ACCESSION NBR: 8307050022 DOC. DATE: 83/06/15 NOTARIZED: NO DOCKET #
 FACIL: 50-397 WPPSS Nuclear Project, Unit 2, Washington Public Powe 05000397
 AUTH. NAME AUTHOR AFFILIATION
 BOUCHEY, G. D. Washington Public Power Supply System
 RECIP. NAME RECIPIENT AFFILIATION
 SCHWENCER, A. Licensing Branch 2

SUBJECT: Forwards response to request for supporting documentation & per Tech Spec second draft discussed during 830523-26 meetings. Tentative schedule for preparation of proof & review copy listed.

Subject: NUCLEAR PROJECT NO. 2
DRAFT TECHNICAL SPECIFICATION

TECHNICAL SPECIFICATION LOG ITEM RESPONSES

Item #17

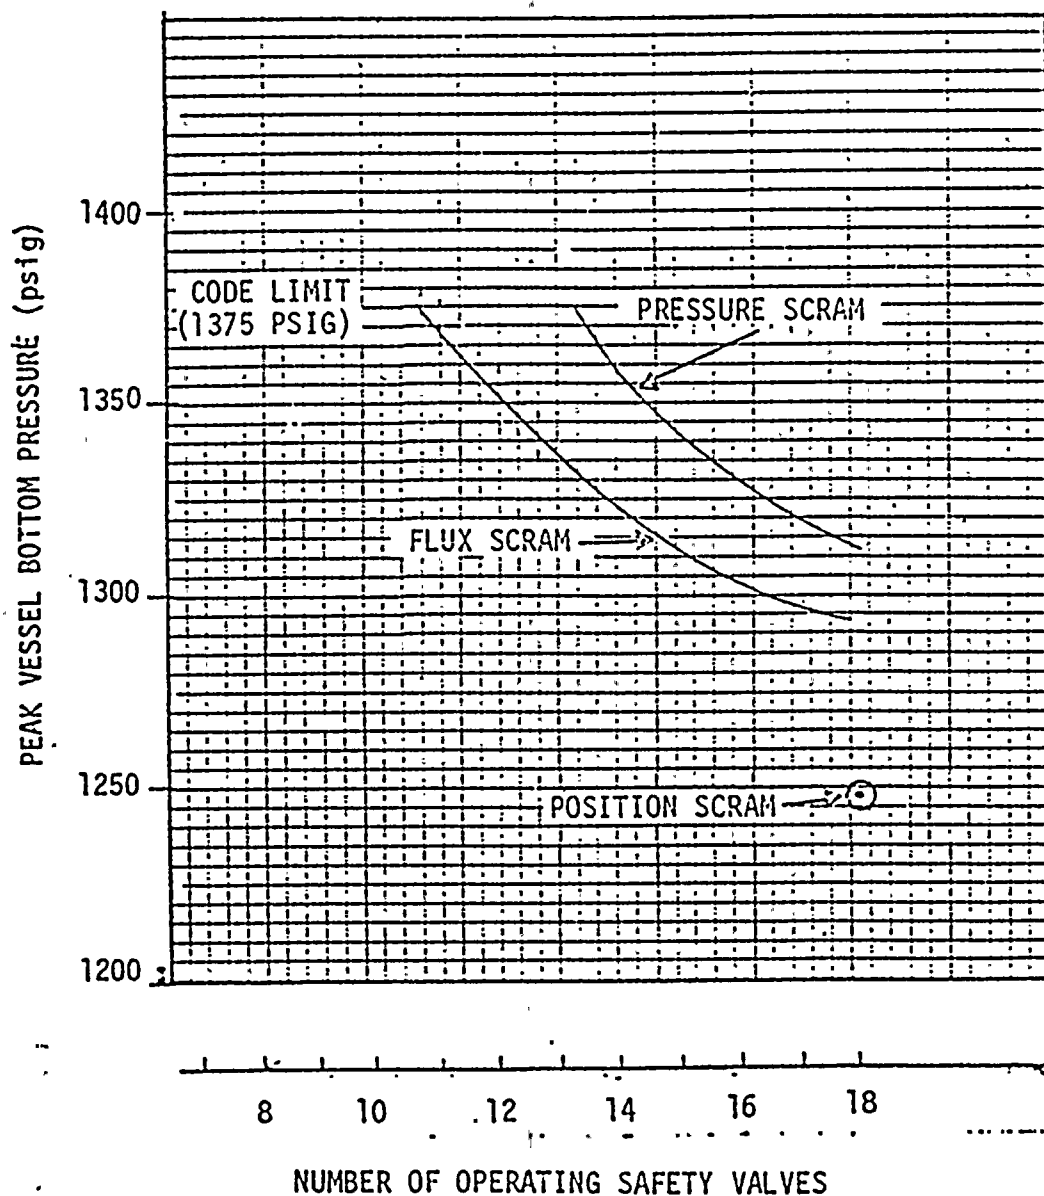
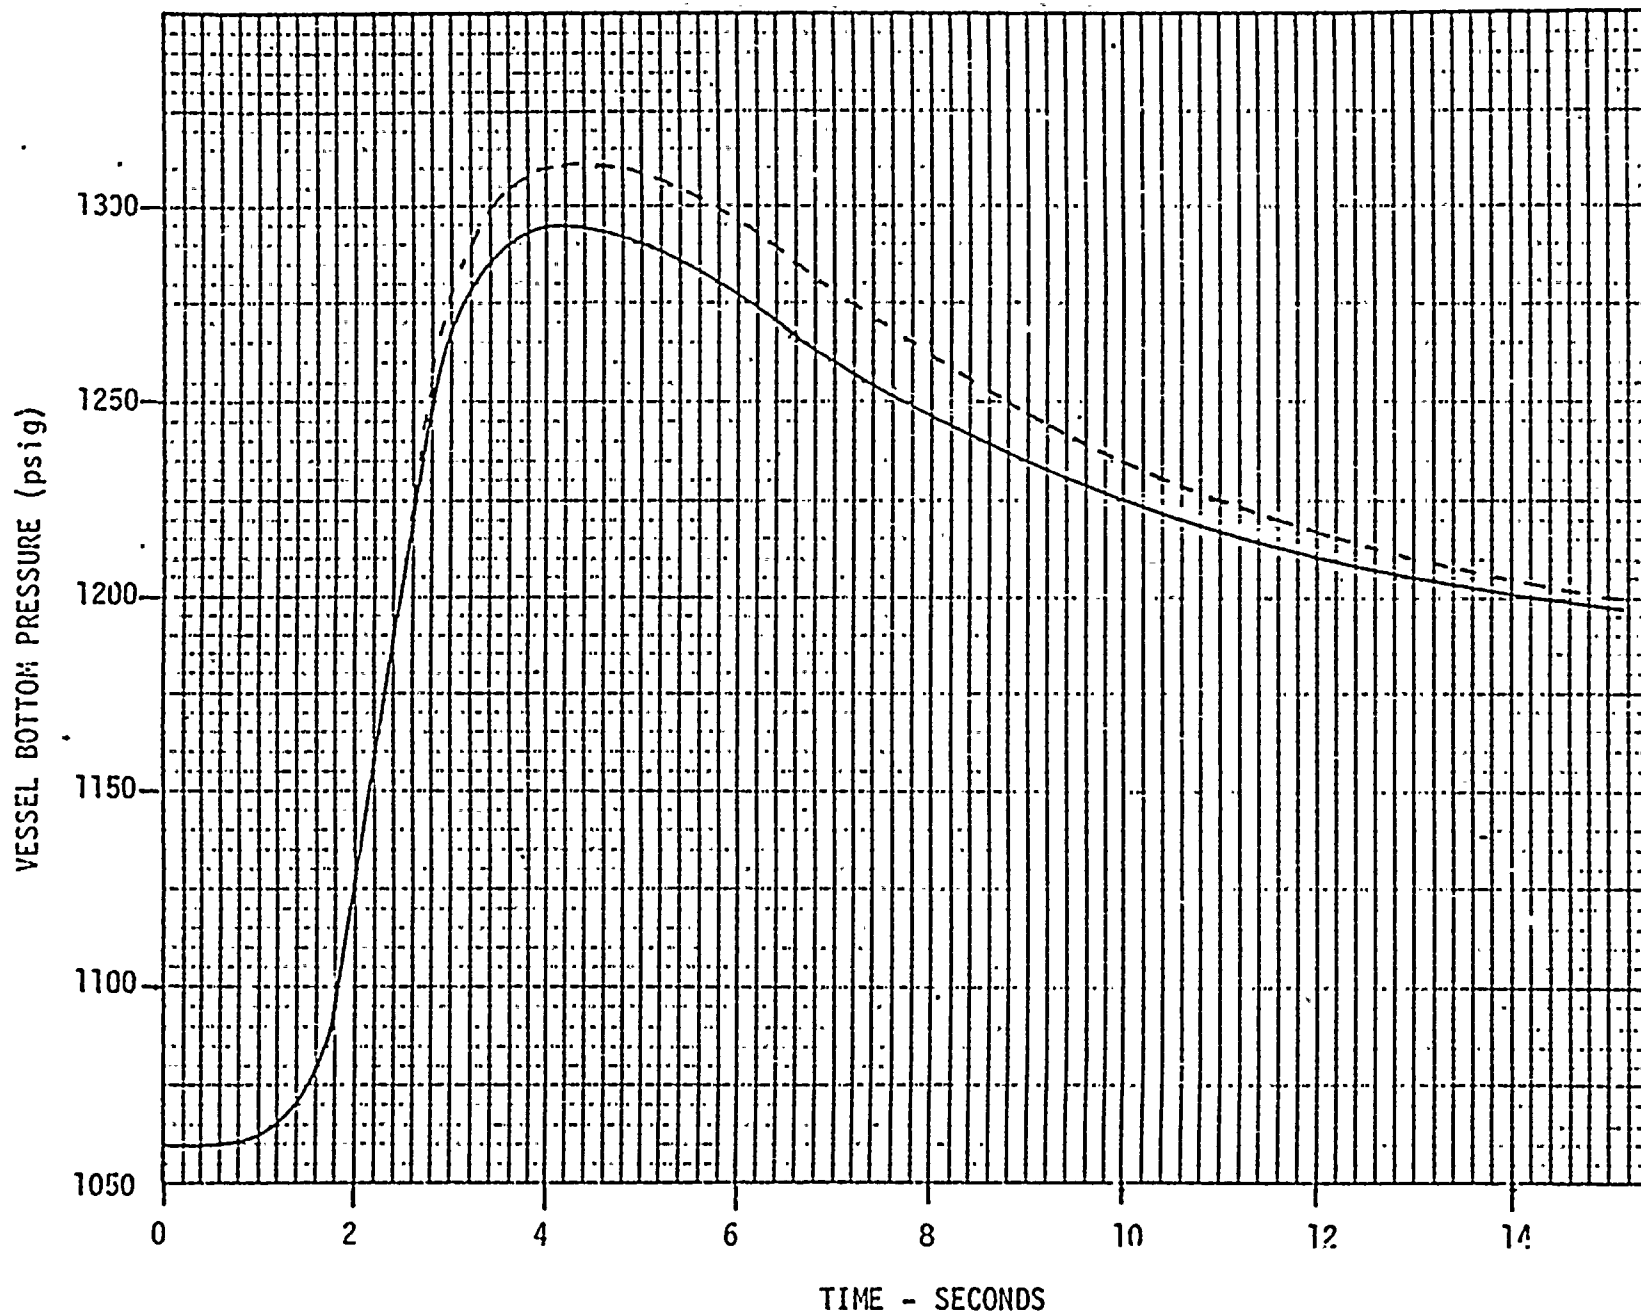
Item #17: Reactor Vessel Overpressure Protection Design Report, Document 22A4106, Rev. 2, states that a MSIV closure with scram signal derived from indirect means (flux versus directly from MSIV closure logic) is the most severe overpressure transient. The analyses results, indicated on Figure 3 and FSAR Figure 5.2-4, indicates that 12 operating safety relief valves are required to limit the pressure response to less than the code limit of 1375 psig. A copy of the document is attached for your information. Note that Susquehanna Tech Spec requires 10 of 16 valves operable.

In addition, the Reactor Vessel Overpressure Protection Analysis was redone using the ODYN code. This analysis shows a 28 psi improvement (reduction) in peak vessel pressure assuming a MSIV-flux scram initiating event. Using standard GE design practice of applying a 40 psi design margin to code pressure limits results in a peak pressure analytical limit of 1335 psig. With the 28 psi improvement from ODYN, the analytical pressure transient as a function of safety relief valve capacity intersects the analytical limit at 11+ valves required operable. Therefore, 12 SRVs was selected as the minimum operable number of valves.
